Re: Public Utility District No. 2 of Grant County, Washington Temperature Modeling Report for the Priest Rapids Project

TEMPERATURE MODELING FOR THE PRIEST RAPIDS PROJECT

FINAL REPORT

APPENDIX H: STAKEHOLDER COMMENTS ON REPORT AND MODEL

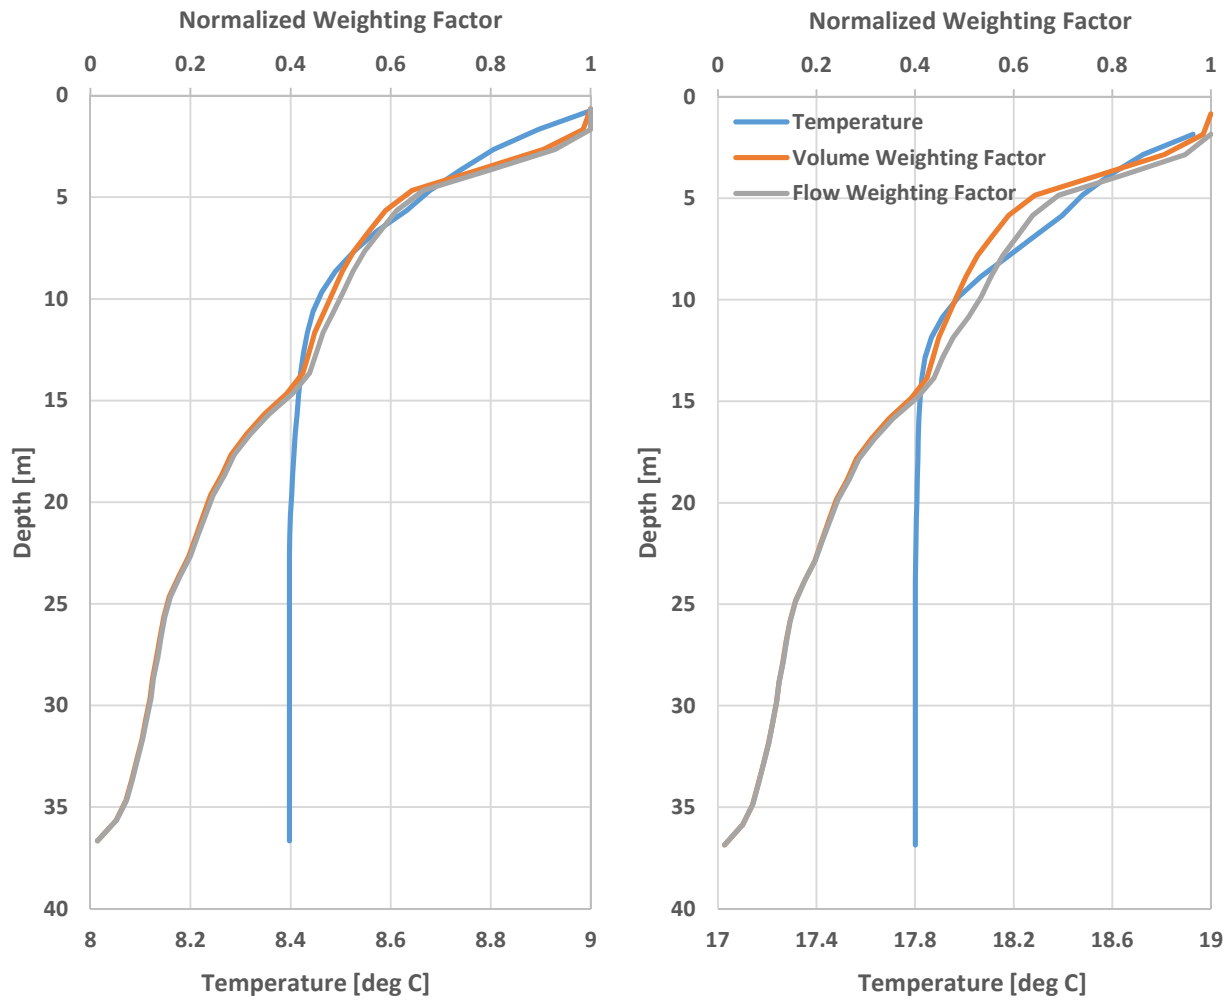
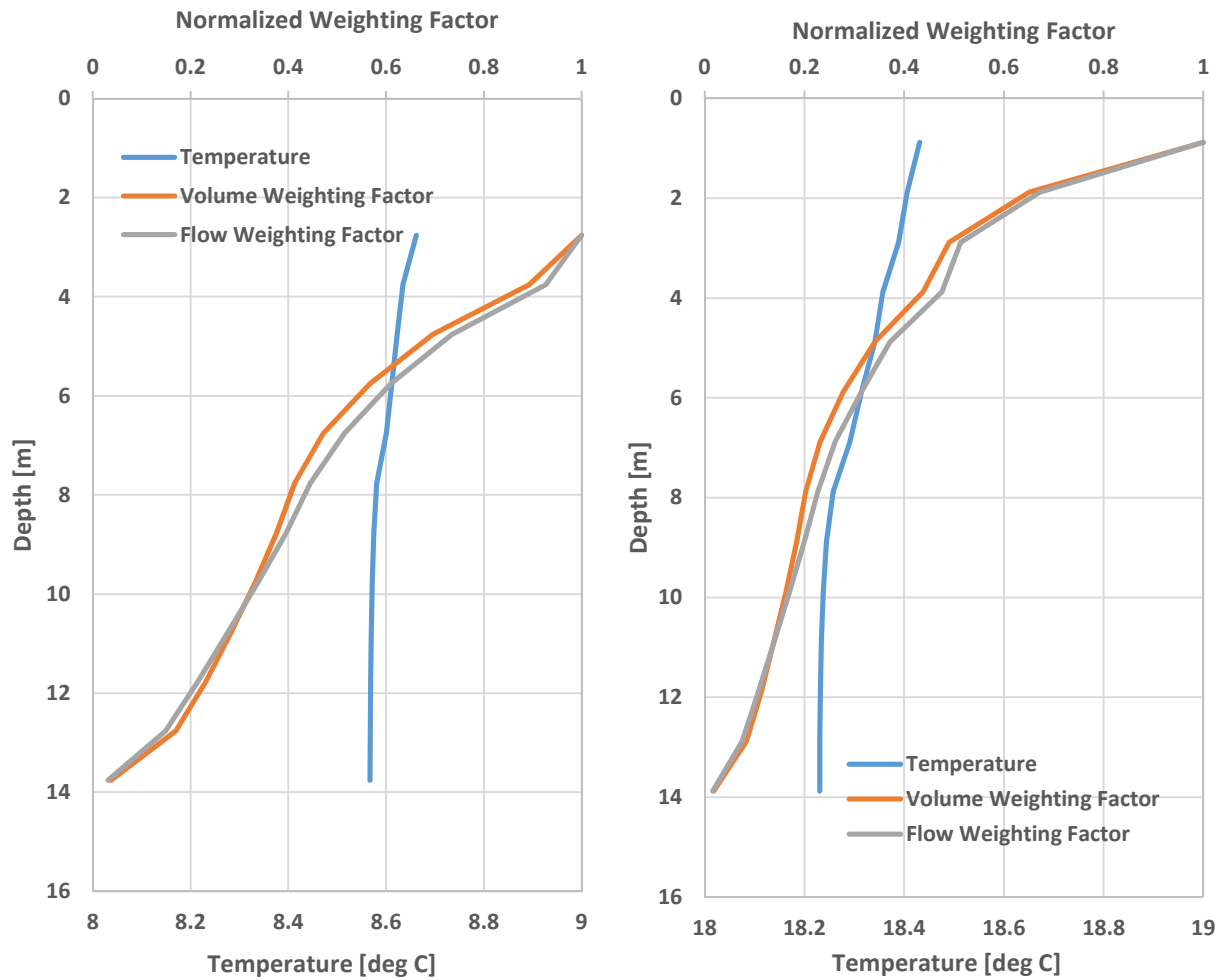
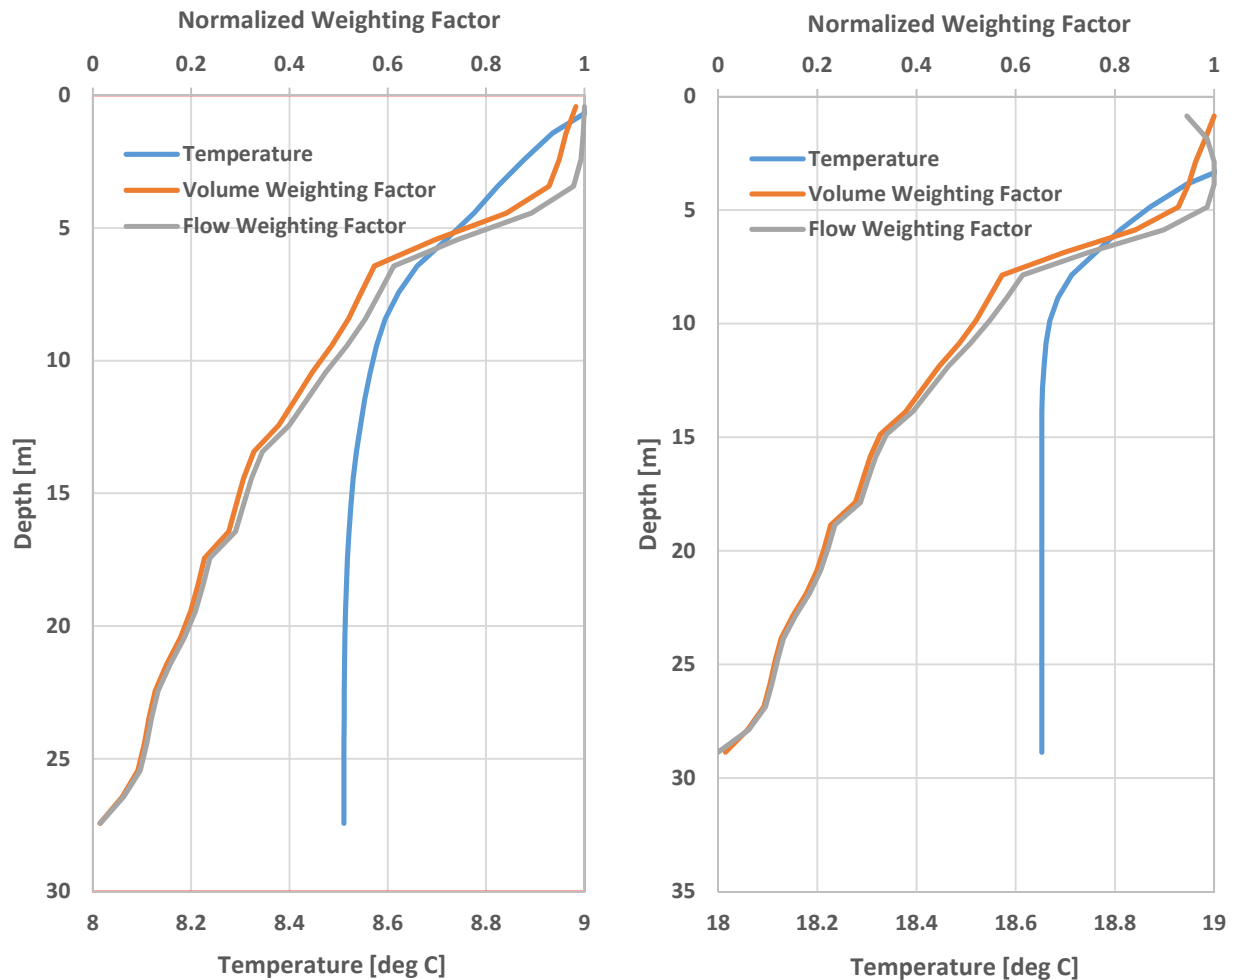
4	<p><u>Water Column Temperature Averaging</u> Some vertical profiles are presented in the report but there wasn't sufficient resolution to the scale obscuring the ability to properly evaluate variation in water column temperatures.</p>	<p>We have added illustrations with adjusted scales as requested. Please note that this has resulted in different scales for different months (e.g. May and September).</p>
		5&6	<p><u>Pre and Post Hydroelectric Hydraulics</u> The greater volume that characterizes the current condition assimilates greater heating loads with relatively lower effective change in temperature – it provides a greater heat storage capacity. For this reason, the study needs to clearly present why the assessment approach taken is an appropriate one. The report should clearly provide hydraulic metrics (graphic and table form) for assessment points comparing the pre and post hydroelectric conditions.</p>	<p>We have add graphs and tables to the report, as requested, to clearly present why the assessment approach selected is appropriate.</p>

Figure 45: Maximum Annual 7-DADMax Queried at Depths by River-Mile, 2012

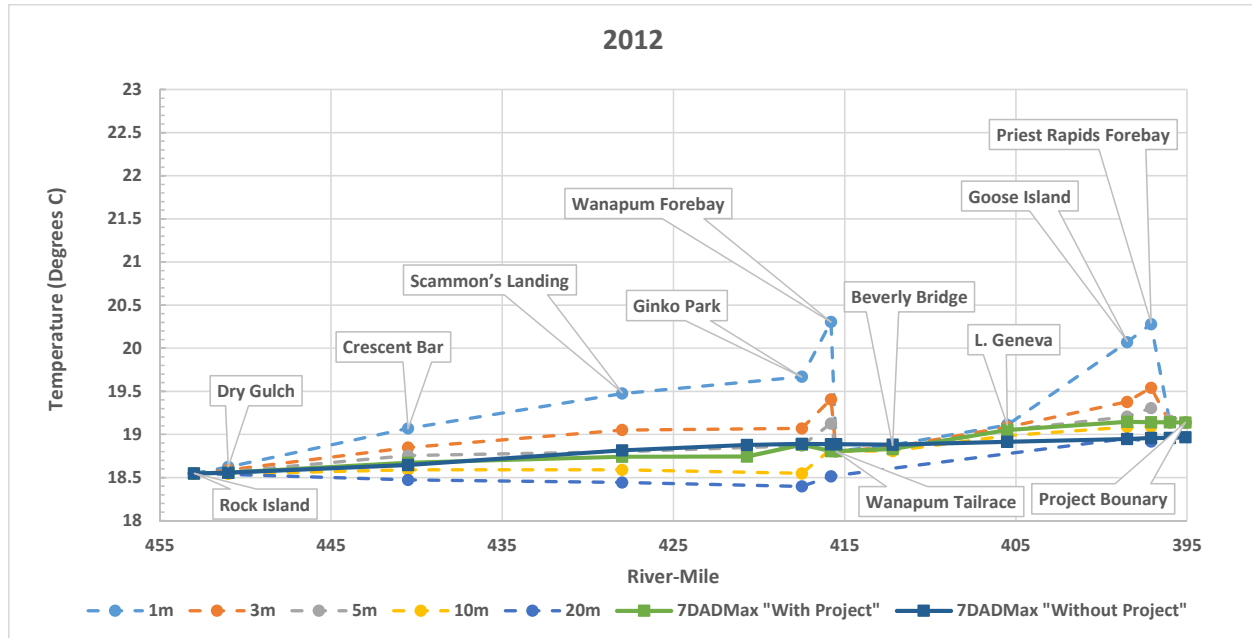
9	<p><u>Other Bits and Pieces</u></p> <ul style="list-style-type: none"> The report should provide a graphic(s) depicting longitudinal temperature profiles, for various depths, through the study area while also indicating the four assessment locations. 	We have added longitudinal profiles as requested.
		9	<p><u>Other Bits and Pieces</u></p> <ul style="list-style-type: none"> The calibration of the model for the Priest Rapids forebay appears to be challenged (figure 32). The calibrated model output is biased – routinely predicting lower temperatures than typically observed during each of the study years examined. 	As stated in Section 4.4 the model is neither biased high or low. Figure 32 illustrates deviations of the model low during cold periods and high during hot periods. If anything, the model may be biased high for years like 2010 as illustrated in Figure 32.
		9	<p><u>Other Bits and Pieces</u></p> <ul style="list-style-type: none"> In providing an argument for low project impact (section 5.2.1) the report points out that the criteria were only exceeded a minimal number of times but bases that on counting days outside of the critical July/August period (i.e. winter months etc.). Along this thinking, it can also be argued that at the Priest Rapids forebay that the criteria is exceeded 40% of the time (occurring at least once each year for 4 of the 10 year assessment period) – refer to figure 45. 	No change was made in the report or model.
